Village of Arlington Heights
Conceptual Plan Review Committee
Virtual Meeting
September 9, 2020
6:45 PM

Item: 2123 S. Arlington Heights Rd. Wingspan Mixed-Use - T1703

VILLAGE OF ARLINGTON HEIGHTS **STAFF DEVELOPMENT** **COMMITTEE REPORT**

Temp File Number: T1703
Project Title: 2123 S. Arlington Heights Rd – Wingspan Mixed Uses
Address: 2121-2123 S. Arlington Heights Rd.
PIN: 08-16-202-005, -011, -022, -023

Graphic 1: Site Access

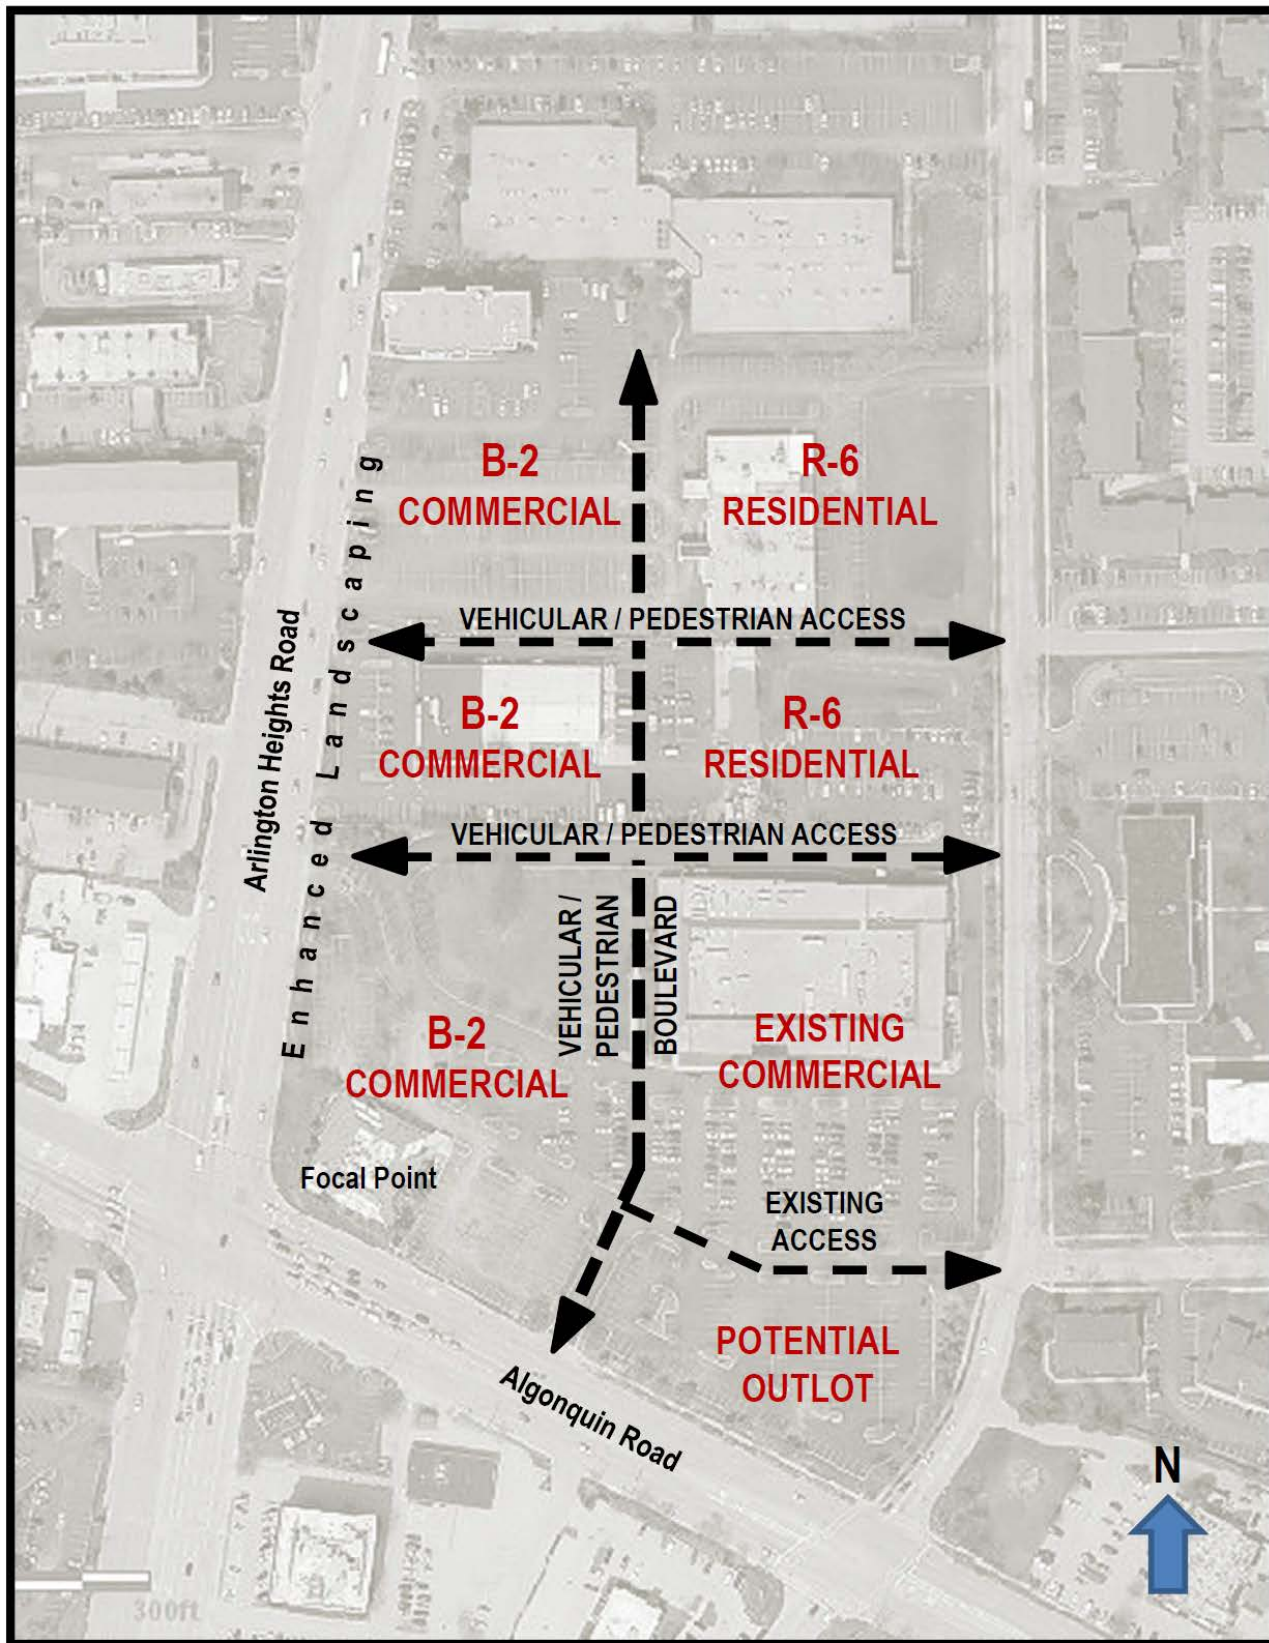
The Plan also references a new traffic signal and pedestrian crosswalk adjacent to this site (see Graphic 1 below), and the petitioner's conceptual site design has aligned their proposed access to Arlington Heights Road to take this feature into account. The petitioner will need to coordinate with IDOT and their traffic consultant to determine if the new traffic signal is warranted, or whether anticipated traffic volumes do not necessitate the traffic signal at this time.

Finally, given the future redevelopment in this area, the petitioner will be required to provide reciprocal access to the south and north, if and when those properties redevelop and provide reciprocal access back to the subject property. This area is envisioned to become a mixed-use and pedestrian friendly neighborhood, and these connections will enhance vehicular and pedestrian connectivity in this area. The Village has prepared a schematic showing how future cross access should function in this area as it redevelops in the future. The petitioner's site plan has accommodated for the connectivity and cross access as referenced in the schematic (provided at the end of this report for reference).
